CADIA EAST GOLD/COPPER PROJECT
Biodiversity Offset Area Modification 06_0295 – Mod 7

NSW Government
Department of Planning & Environment

Figure 3: Area to be excised from the Belubula River/Flyers Creek Area

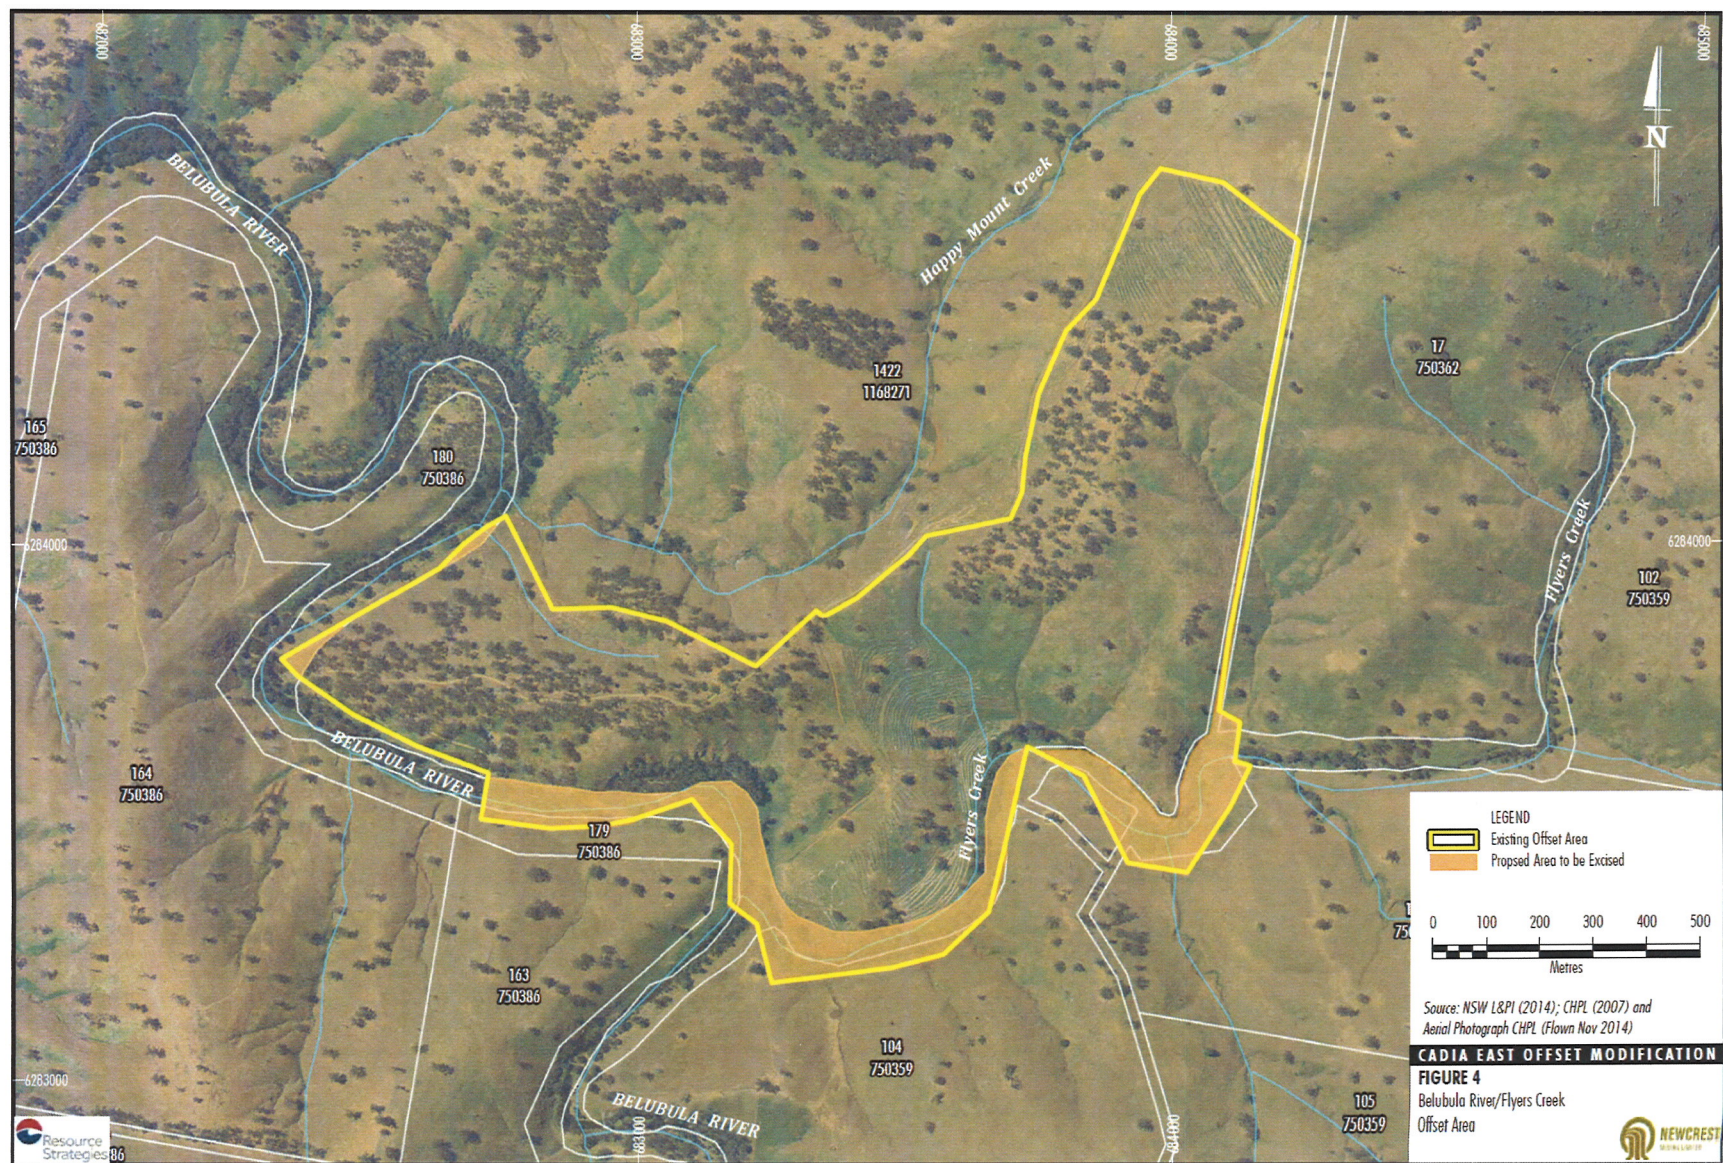
Issue	Consideration	Recommendation
Biodiversity	<u>Belubula River/Flyers Creek offset area</u> - Cadia proposes to excise 14.2 ha from the offset area in order that the southern boundary of the offset is aligned with its official boundary of the lot(s). In this regard, Cadia notes that the original offset area boundary was based on the fence lines, which have since been found to not correlate accurately with the cadastral boundary. - The vegetation communities within the area to be excised include 11.7 ha of River Oak Forest, 0.3 ha of Box-Gum Woodland EEC and 2.3 ha of Exotic Grassland. Both areas of native vegetation are in poor condition due to a high dominance of exotic species, poor structure and low native species richness.	Amendments to condition 38 of schedule 3 and Appendix 6 to reflect the revised biodiversity offset strategy.
	<u>Black Rock Range offset area</u> - Cadia proposes to excise 16.5 ha from the offset area due to cadastral issues discovered while securing the offset. These issues include the presence of a Trig Station on Crown land within the Range and an area on the southern tip of the offset that is farmed by a neighbouring landowner. - The vegetation communities within the southern area to be excised include 2.7 ha of Box-Gum Woodland EEC, 0.2 ha of Red Stringybark Woodland and 11.0 ha of Exotic Grassland. Both areas of native vegetation are in poor condition due to a high dominance of exotic species, poor structure and low native species richness. - The Trig Station area to be excised supports (and is surrounded by) good quality native vegetation and contains approximately 0.5 ha of the Commonwealth-listed Box-Gum Grassy Woodlands and Derived Native Grasslands CEEC. Despite being excised from the offset the remnant would in effect be managed as part of the offset by virtue of the fact it is indistinguishable from the surrounding native vegetation and is unlikely to be subject to significant disturbance in the future given its use.

Figure 5: Proposed 'Stratton Vale' replacement offset area

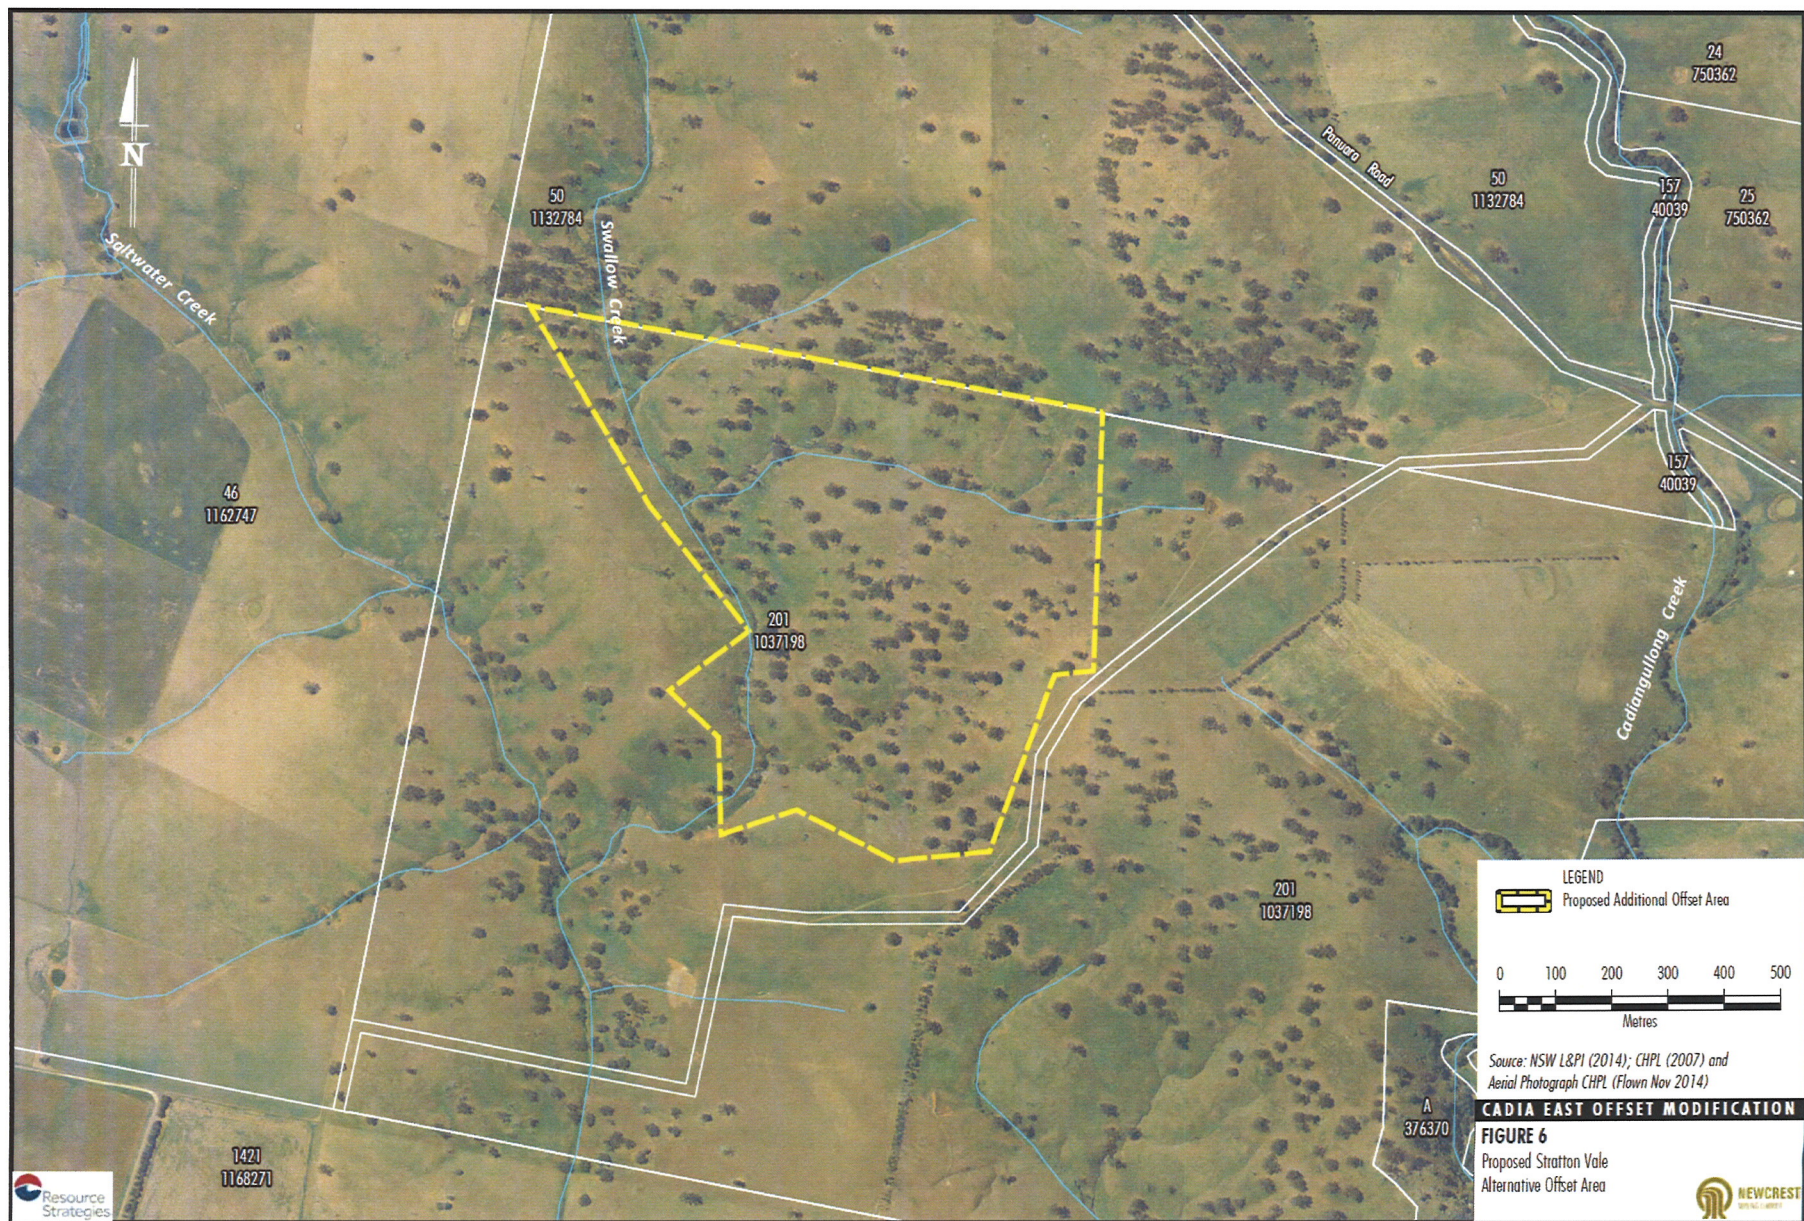
OEH is satisfied that the revised offset strategy is adequate although it recommended that Cadia be required to develop a Biodiversity Management Plan to improve the relatively poor condition of the native vegetation on the Stratton Vale offset site.

<u>New Stratton Vale offset area</u> - Cadia proposes to replace the excised offset areas with a new 60.7 ha offset area on the Cadia-owned Stratton Vale property. - The vegetation communities within the offset area include 45.4 ha of Box-Gum Woodland EEC, 1.2 ha of Derived Grassland and 14.1 ha of Exotic Grassland. The Commonwealth-listed Box-Gum Grassy Woodlands and Derived Native Grasslands CEEC was not recorded on the site. - Both areas of native vegetation are in poor condition due to a high dominance of exotic species, poor structure and low native species richness. However, the area is of similar condition to the areas being excised (with the exception of the Trig Station) and is almost twice as large as the excised areas. - Consequently, the Department and OEH are satisfied that the replacement offset area at Stratton Vale is suitable and is 'like for like', being of equivalent vegetation types and overall condition as the areas to be excised. - The Department supports the OEH recommendation that the replacement offset be appropriately managed to improve its condition. In this regard, the existing conditions already require Cadia to prepare and implement a comprehensive Landscape Management Plan (which includes management of the offset areas), and conditions requiring Cadia to review and update the management plan to reflect the proposed modification.
